**SUBJECT:** Seventh Five-Year Remedy Review Report for Savannah River Site Operable Units with Native Soil Covers and/or Land Use Controls (U) Aiken, South Carolina (SRNS-RP-2023-00715, Revision 1, June 2024) (Redline Pages), Seventh Five-Year Remedy Review Report for SRS Operable Units with Native Soil Covers and/or Land Use Controls Fact Sheet (SRNS-RP-2023-00717, June 2024) (Redline Page), and Savannah River Site's Responses to the Regulatory Comments on the Revision 0 Document, SEMS Number: 00

3. SRS Responses to South Carolina Department of Health and Environmental Control Comments on the Seventh Five-Year Remedy Review Report for Savannah River Site Operable Units with Native Soil Covers and/or Land Use Controls (U) (SRNS-RP-2023-00715, Revision 0, December 2023)

4. SRS Responses to United States Environmental Protection Agency Comments on the Seventh Five-Year Remedy Review Report for Savannah River Site Operable Units with Native Soil Covers and/or Land Use Controls (U) (SRNS-RP-2023-00715, Revision 0, December 2023)

**SRS Responses to United States Environmental Protection Agency  
Comments on the  
Seventh Five-Year Remedy Review Report for Savannah River Site Operabl

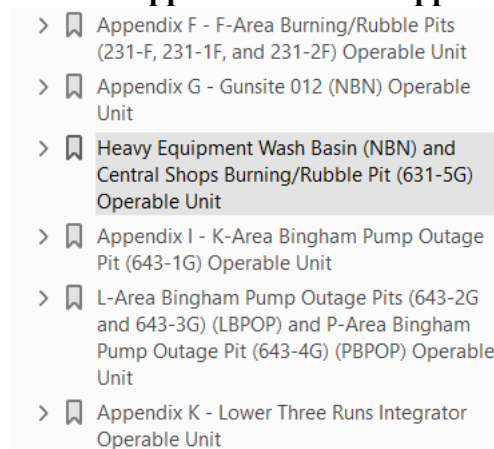
- b.** The entry for the Wetland Area at Dunbarton Bay in Support of the Steel Creek IOU includes a protectiveness determination and statement. However this OU was not evaluated in the 6<sup>th</sup> FYR for or SRS OUs with Native Soil Covers and/or LUCs (remedy implementation for this OU was not complete during that review cycle). **Recommend changing both the protectiveness determination and statement entries to read “NA” and add a superscript “a” to the Operable Unit description, to reference footnote “a” to the table.**

**Response: Agree.**

**Table 5 will be revised to correct the entry for the Wetland Area at Dunbarton Bay in Support of the Steel Creek IOU as requested.**

**Figure K-3. Lower Three Runs IOU Ponds and Canal System**

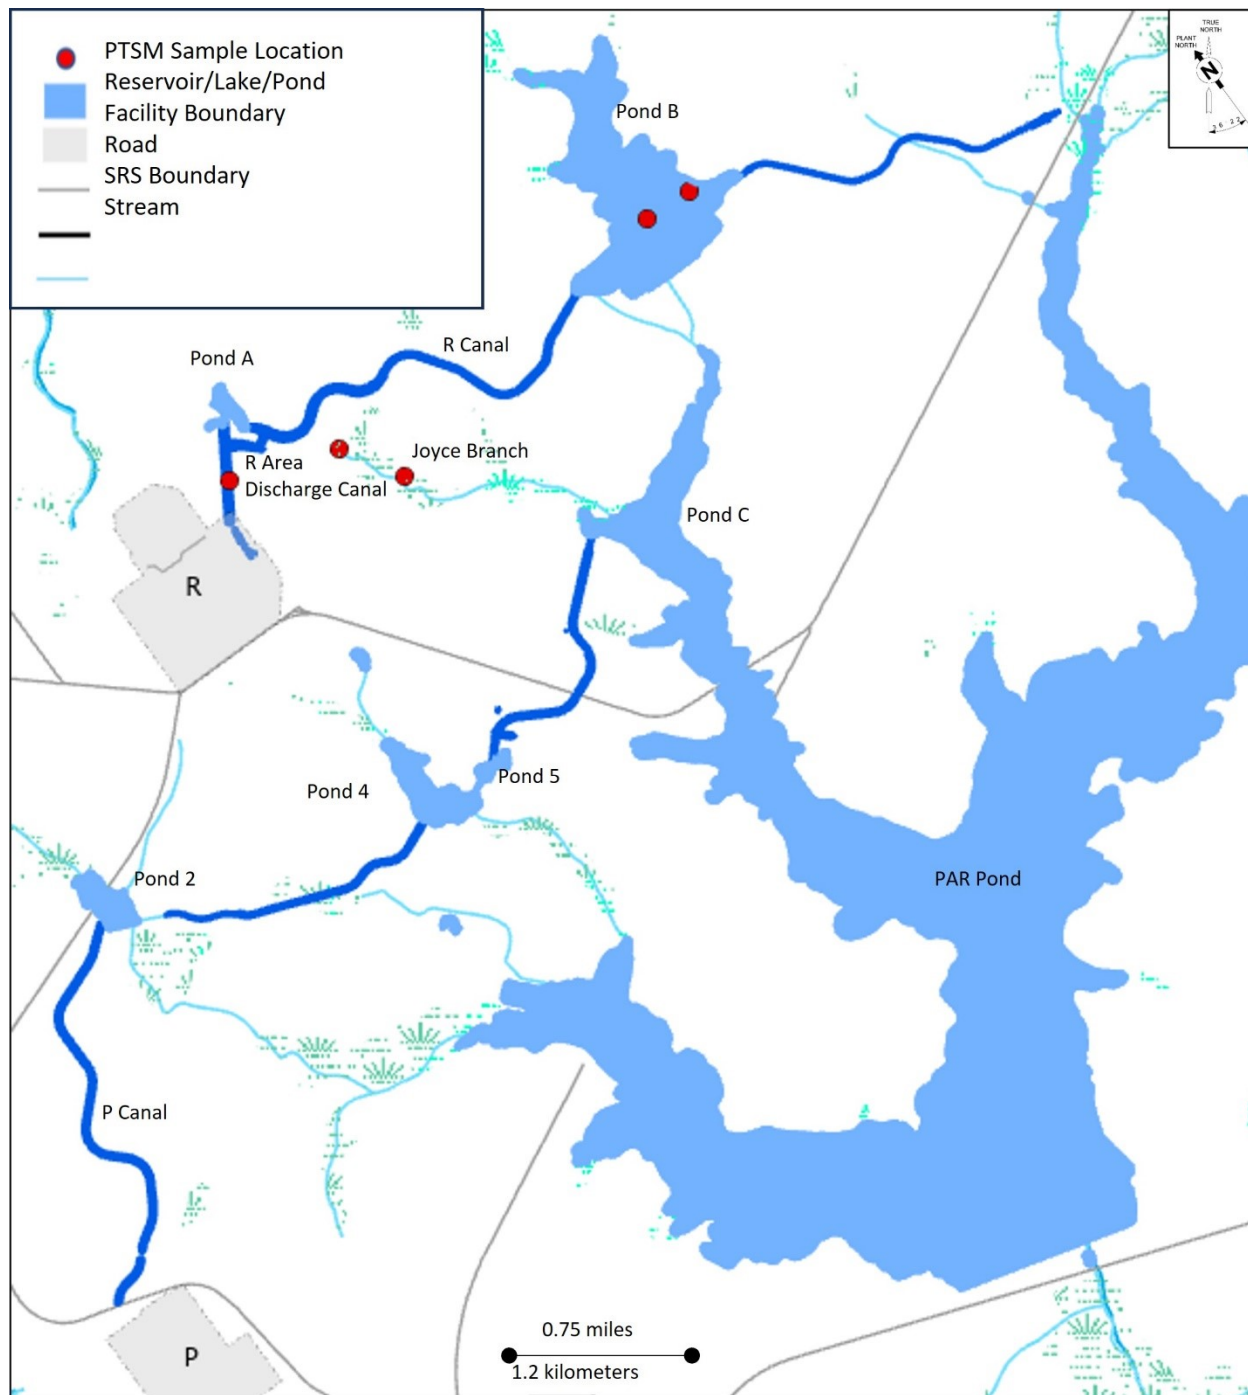
- 6. Figure K-3, Lower Three Runs Integrator Operable Unit Ponds and Canal System, Page K-25:** Pond 2 is included in a list of areas that are part of the Upper Subunit in Appendix K, Lower Three Runs IOU, Section III, Background; however, it is not shown in Figure K-3. **Please revise Figure K-3 to show the location of Pond 2.**

**Response: Agree.**

Figure K-3 will be updated to include the location of Pond 2. The updated figure is included at the end of these responses.
